## Product Change Notification (PCN)

No.: 01-2019

### Panasonic Pyroelectric Infrared Sensors - PaPIRs

#### Notification of product change

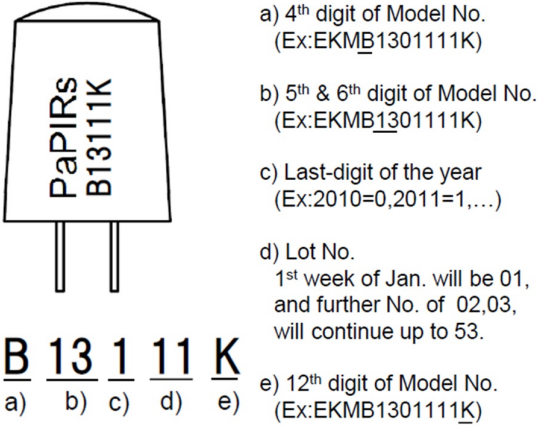
New date code labelling	Part numbers	Marking
 <p>a) The Marking as the table on the right.            b) Last-digit of the year (Ex:2019=9,2020=0,...)            c) Lot No.            1<sup>st</sup> week of Jan. will be 01, and further No. up to 53</p> <p><b>D 9 45</b>            a) b) c)</p> <p><b>Fig. 1: Date code label of the Low Profile Type. This is valid for all types except the Standard Detection Type.</b></p>	EKMB11□□11□	D
	EKMB12□□11□	E
	EKMB13□□11□K	F
	EKMB43□□11□K	G
	EKMC16□□11□	H
	EKMC26□□11□K	I
	EKMC46□□11□K	J
	EKMC76□□11□K	K
